CONSTRUCTION TRAFFIC MANAGEMENT PLAN

Sydney Metro West – Western Tunnelling Package

Unwin St and Kay St 56hr Closure

Document Reference #: SMWSTWTP-GLO-CLJ-TF-PLN-000005

RSA 001

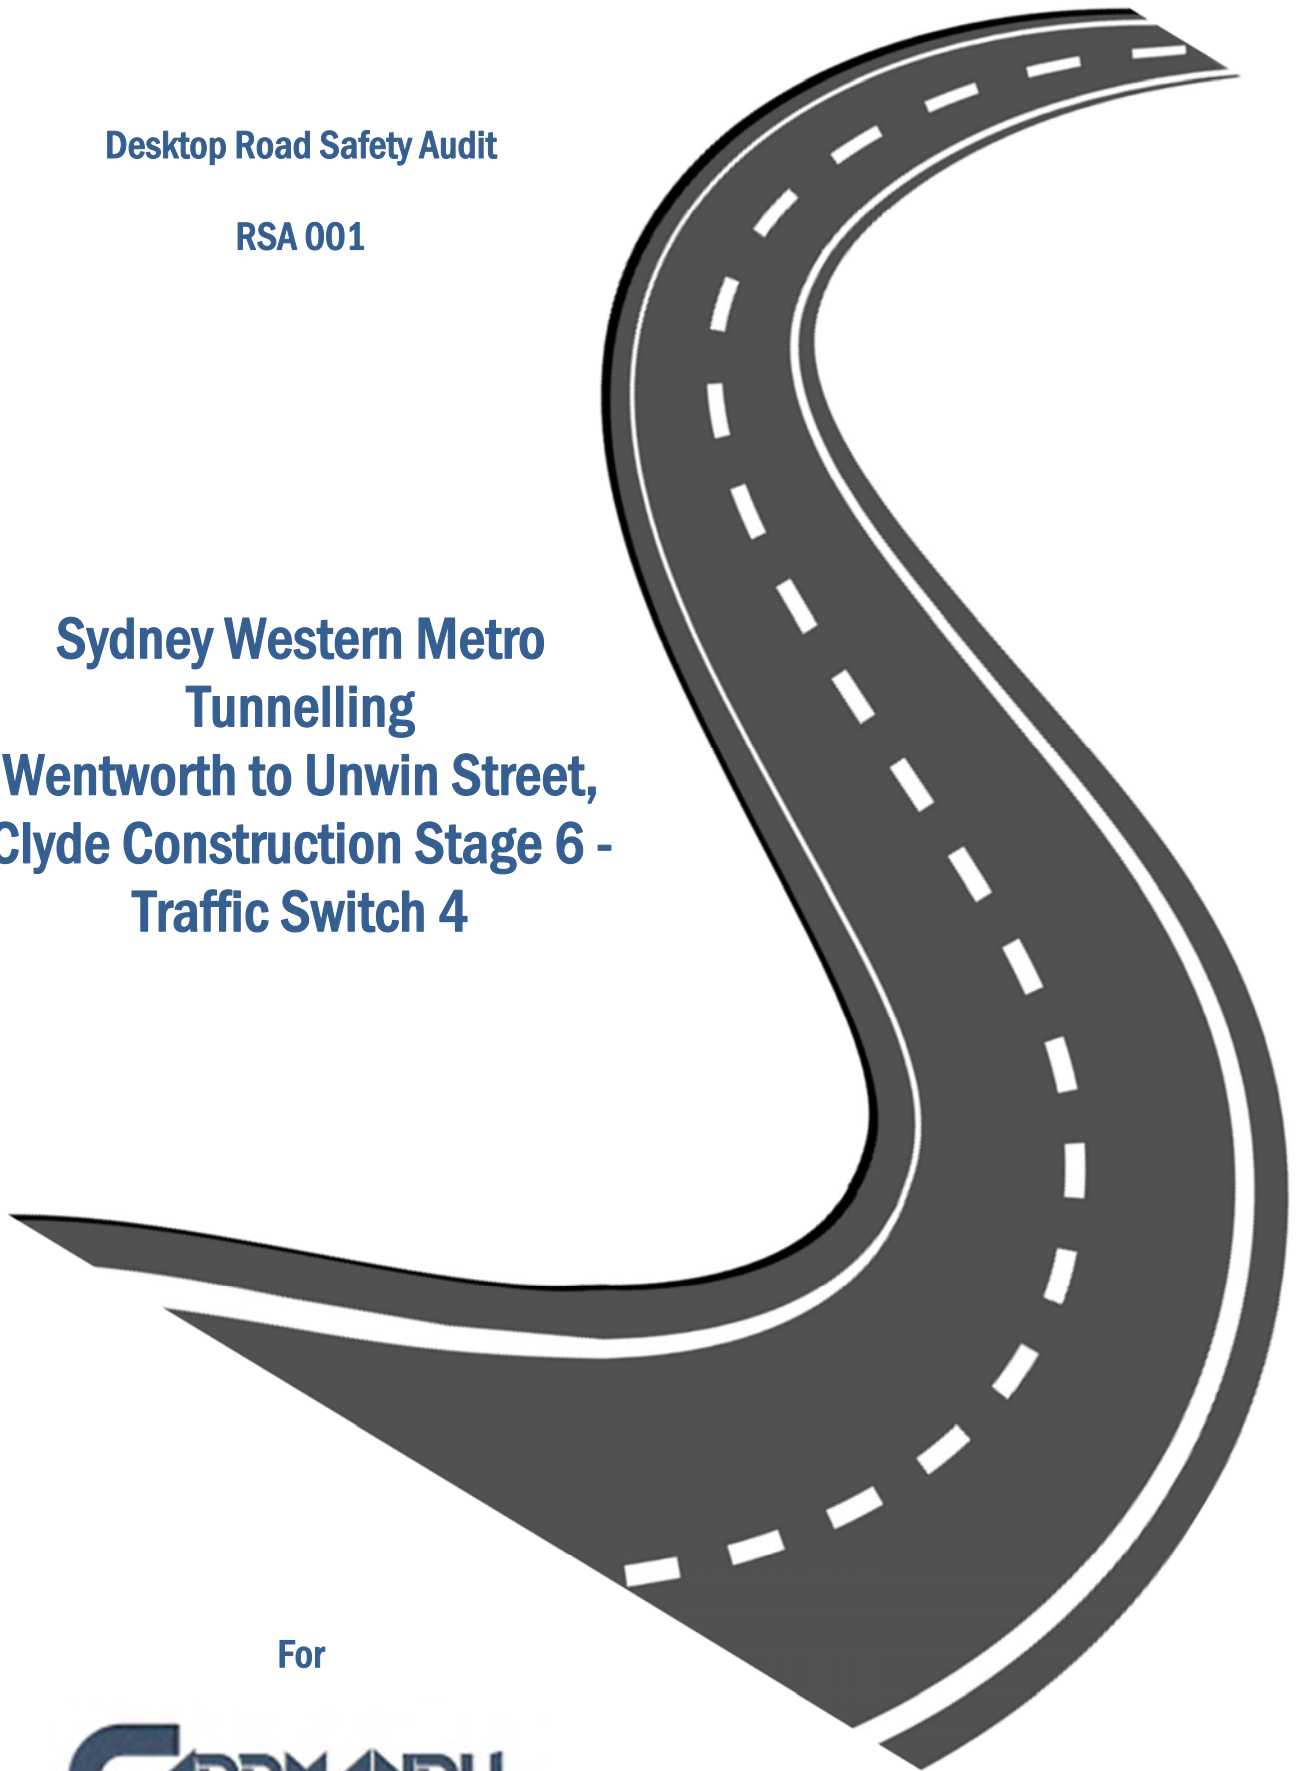
Sheet 4	<p>A. Has consideration been given to ALL road users i.e. safe access for pedestrians and cyclists?</p> <p>B. What measures will there be in place to keep pedestrians to the alternate path route?</p> <p>C. Roadworks speed zone signage needs to be placed on each side of formation on approach in accordance with the TCAWS Manual.</p>	Comment Only			<p>A. Pedestrians through ahead is expected to be at a low – None, only pedestrians would be from Rosehill Gardens Racecourse or Workers at GLC, and Cyclists will adhere to the long term TTM arrangements like other road users.</p> <p>B. TGS was drawn on top of the Design Drawing, which has caused confusion, and the RSA has looked at this as part of the TGS.</p> <p>C. Long Term 40 Km/h Speed zone reduction will be in place through the work area.</p>
LGP 63715 GLC 149 Unwin St Clyde Gate Control

Sheet 4	<p>A. What signage will there be in place to warning approaching traffic of construction vehicles entering.</p>	Comment Only			<p>A. Truck turning Signage will be in placed prior to use of gate.</p>

Sheet 4	<p>A. Does Kay St require heavy vehicle access. If so, will the barrier placement allow for heavy vehicles passing on the bend safely. Turn paths need to be checked.</p> <p>B. Is Kay Street & Unwin Street normally 40km/h? Will need to be signposted if not.</p>	Comment Only			<p><i>A. Barrier alignment has been checked alongside Swept path analyse,</i></p> <p><i>B. Long Term 40 Km/h Speed zone reduction in place through the work area.</i></p>
LGP 61681 GLC 143 Kay St Clyde footpath closure

Sheet 4	<p>A. Ensure the temporary footpath is level with smooth transition to adjacent surface and no other trip hazards.</p>	Comment Only			<p><i>A. Will ensure Temporary footpath is level and smooth transition to adjacent surfaces as to avoid any trip hazards.</i></p>

B. The plans do not indicate whether the temporary footpath will be lit at night				<i>B. If Lighting is insufficient the area light towers/Day makers will be taken into consideration for set up of TGS.</i>
LGP 60632 GLC 136 Kay St Clyde CS3x4x5 TS3

Sheet 4	Show location of hold line at temporary signals	Comment Only			<i>TGS now superseded by the Road closure, "Stop here on red signal" Signage is notated on the TGS with a 6m Distance.</i>

Sheet 5	The plans denote that a 3.5m wide lane must be maintained at all times. Does the 3.5m wide lane provide adequate turning room for safe access to and from adjacent businesses?	Comment Only			<i>There are no longer any adjacent businesses only, only used by GLC and the Racecourse, businesses on Colquhoun St will use Grand Ave for access and egress</i>

Sheet 6	Show location of hold line at temporary signals	Comment Only			<i>Not Temporary signals, it is Boom Gates at the start of the</i>
LGP 60589 GLC 135 Unwin St Rosehill CS3 Pedestrian refuge

Sheet 4	The plans denote that a 3.5m wide lane must be maintained at all times. However, the plan also indicates that traffic cones or other traffic control measures will be required to delineate the lane. Will a full 3.5m lane width be available? If not, does this reduce the safety for vehicles and pedestrians, particularly if heavy vehicles utilise this road? Also, have the needs of cyclists been considered through this section of roadworks?	Comment Only			<i>3.5m Lane widths will be maintained at all times through the set up.</i>
LGP 59866 GLC 133 Kay St Clyde CS1 TS1

Sheet 4	The plan does not show the available road width, and the lanes appear to be relatively narrow near the temporary traffic signals. The plan should include the location of the hold line for stopped vehicles and ensure there is adequate clearance available between through vehicles and stopped vehicles, particularly if there are heavy vehicles in the traffic flows.	Comment Only			<i>“Stop here on red signal” Signage is notated on the TGS with a 6m Distance. Lane widths are as per the Design Drawings</i>
LGP 63699 GLC 148 Unwin St Clyde Stop Slow

Sheet 4	A. The plans indicate pedestrian movements will be controlled by boom gates, but do not indicate that traffic controllers will be onsite. It is possible that pedestrians may ignore the boom gates, which may result in conflict between pedestrians and construction vehicles.	Comment Only			<i>A. TC's will be on site during this TTM arrangement as to avoid the potential of Pedestrians who walk through the area and causing a optional hazard.</i>

Review Purposes Only					
Sheets 1 - 9	<p>A. It is not clear whether VMS are provided throughout the precinct to inform motorists about the road closures and detours. It would be best to inform drivers to avoid the area and take alternative routes rather than become frustrated or confused at the</p>	Comment Only			<p>A. VMS will be in place 10 days or more prior to the Road Closure as per the VMS strategy in the CTMP.</p>
